**DODDRIDGE COUNTY COMMISSION
DODDRIDGE COUNTY, WEST VIRGINIA**

**DODDRIDGE COUNTY ADMINISTRATIVE ANNEX
WEST UNION, WEST VIRGINIA
THRASHER PROJECT #060-0981**

**ADDENDUM #2
March 25, 2021**

SHEET No.
C5.00

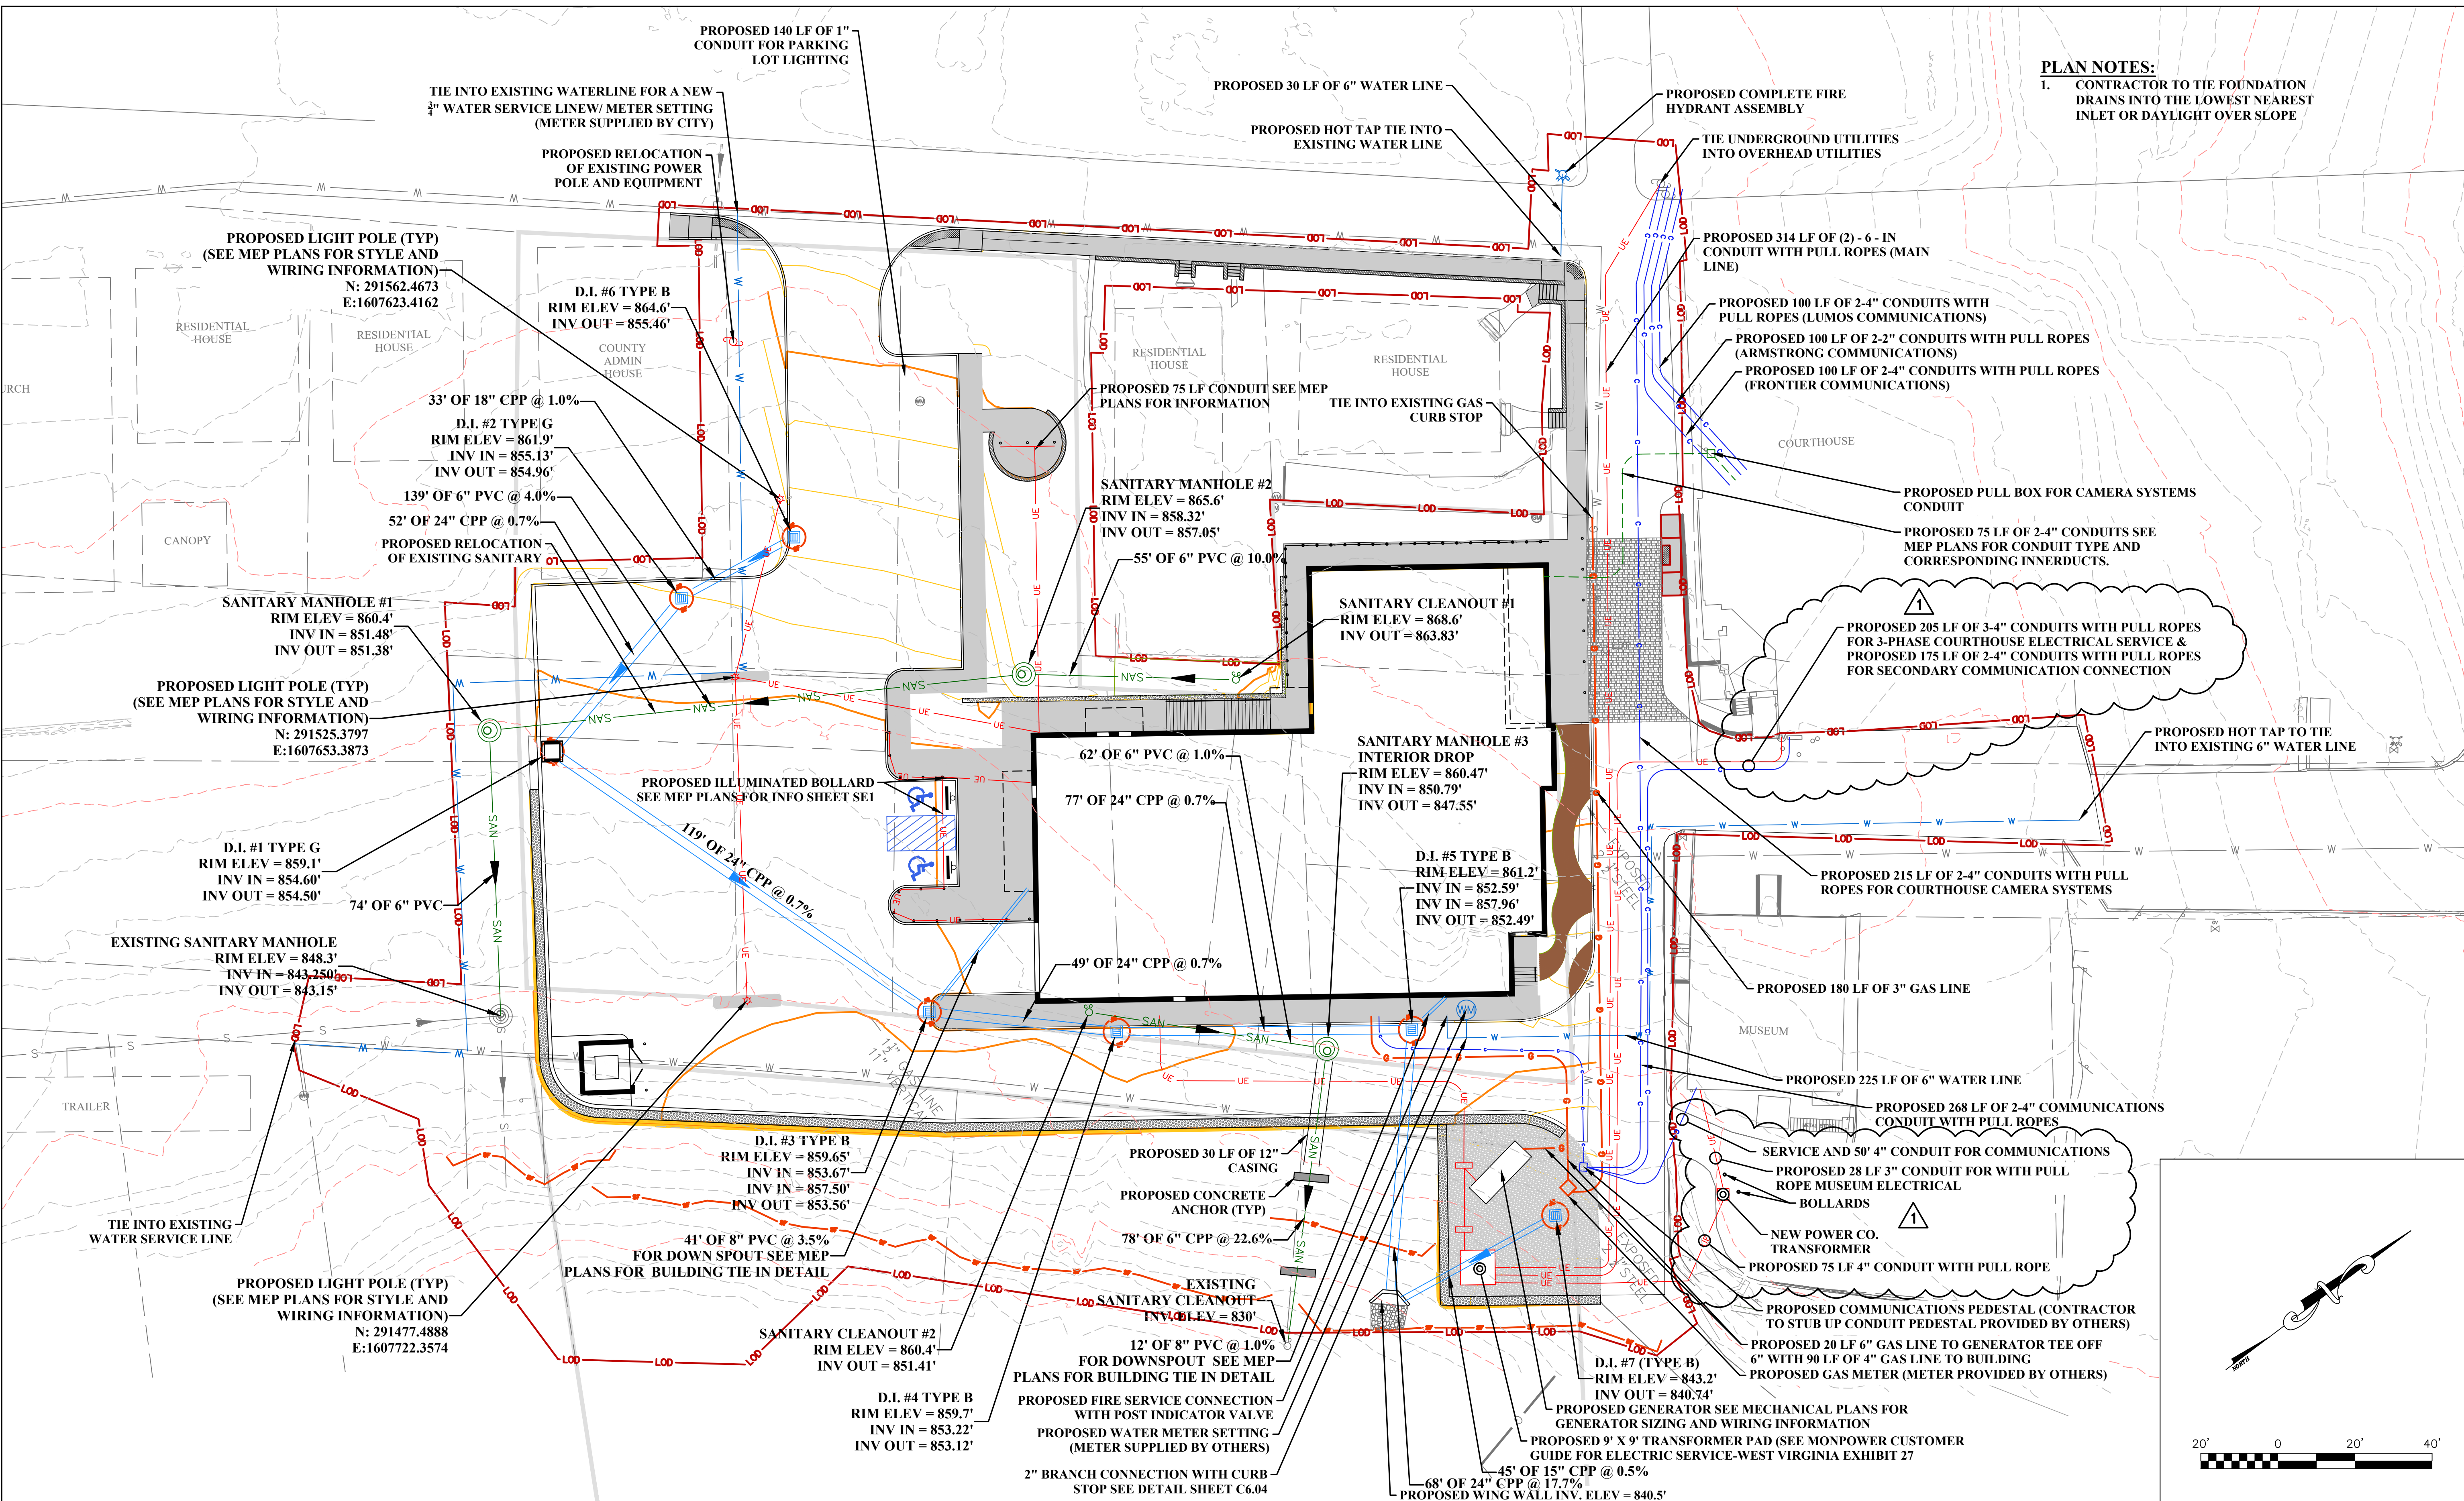
1. Reference drawing sheet SE1. See attached sketches SKE-1, SKE-2 and SKE-3 for details on electrical services to the Courthouse and Jail/Museum.
2. 1.Reference drawing sheet E4.01. See ELECTRICAL RISER. Omit CT Cabinet and Meter. Power company will meter at the power company transformer. Omit Riser Note "B". Conduit and feeder from the power company transformer will go to the ATS.
3. REPLACE SHEET C4.00 SITE PLAN
4. REPLACE SHEET C4.04 WALL PROFILE
5. REPLACE SHEET C5.00 UTILITY PLAN

NO.	BY	DATE	DESCRIPTION
1	BD	3/25/2021	CONDUIT LOCATION AND SIZE MODIFICATIONS

SKE-1

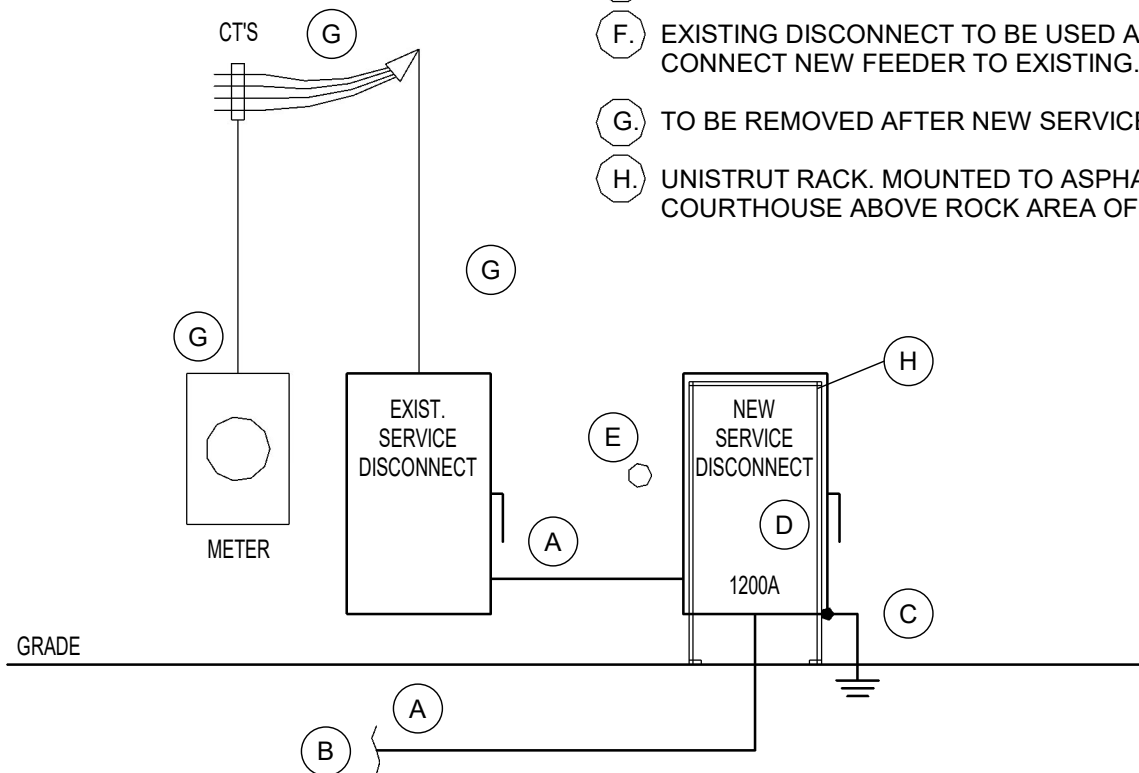
- (A.) (3)-4" CONDUITS WITH (4)-500MCM CONDUCTORS.
- (B.) TO POWER COMPANY TRANSFORMER SEE SKETCH SKE-3.
- (C.) GROUND PER NEC.
- (D.) 3P/1200A, 240V, HEAVY DUTY, NEMA-3R, FUSED DISCONNECT . FUSE AT 1,000 A.
- (E.) DO NOT BLOCK EXISTING VENT.
- (F.) EXISTING DISCONNECT TO BE USED AS A JUNCTION BOX. CONNECT NEW FEEDER TO EXISTING.
- (G.) TO BE REMOVED AFTER NEW SERVICE IS INSTALLED.
- (H.) UNISTRUT RACK. MOUNTED TO ASPHALT AND TIED BACK TO COURTHOUSE ABOVE ROCK AREA OF WALL.

SKE-2

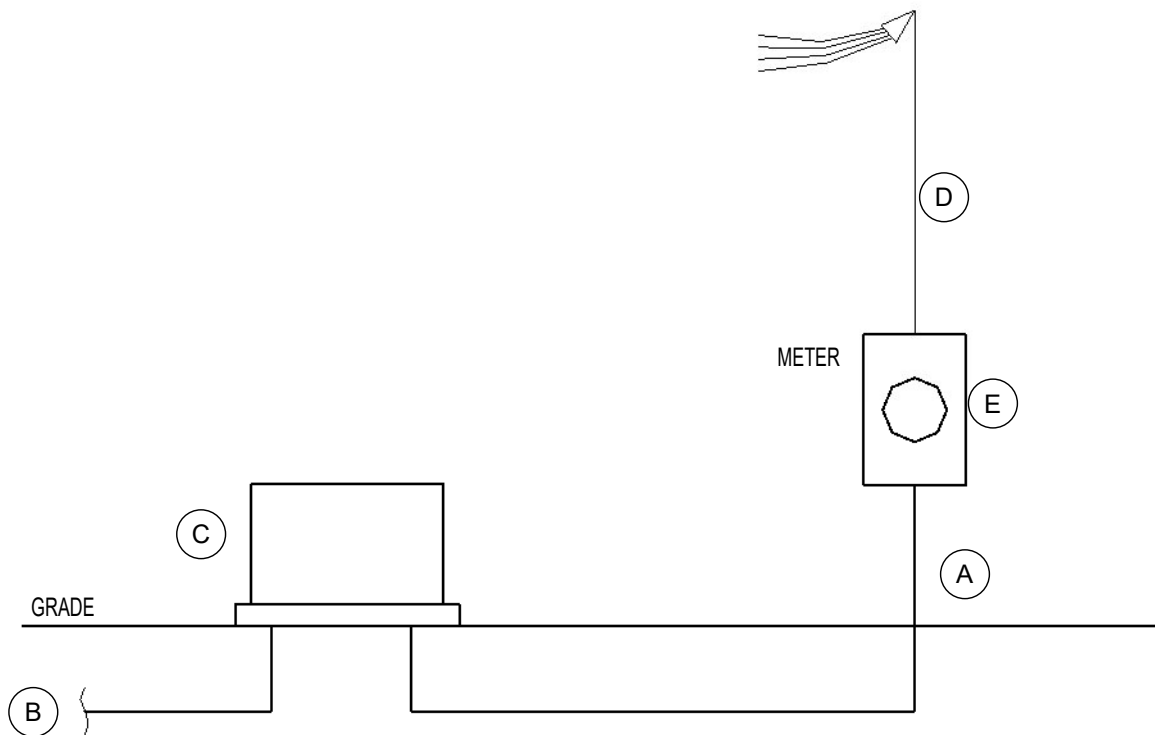
- A. 3" CONDUIT WITH (3)-3/0 CONDUCTORS.
- B. 4" CONDUIT WITH PULL STRING TO POWER CO. TRANSFORMER. SEE SKETCH SKE-3.
- C. NEW POWER COMPANY TRANSFORMER. COORDINATE INSTALLATION REQUIREMENTS WITH POWER COMPANY.
- D. REMOVE AFTER NEW SERVICE IS INSTALLED.
- E. EXISTING TO REMAIN.
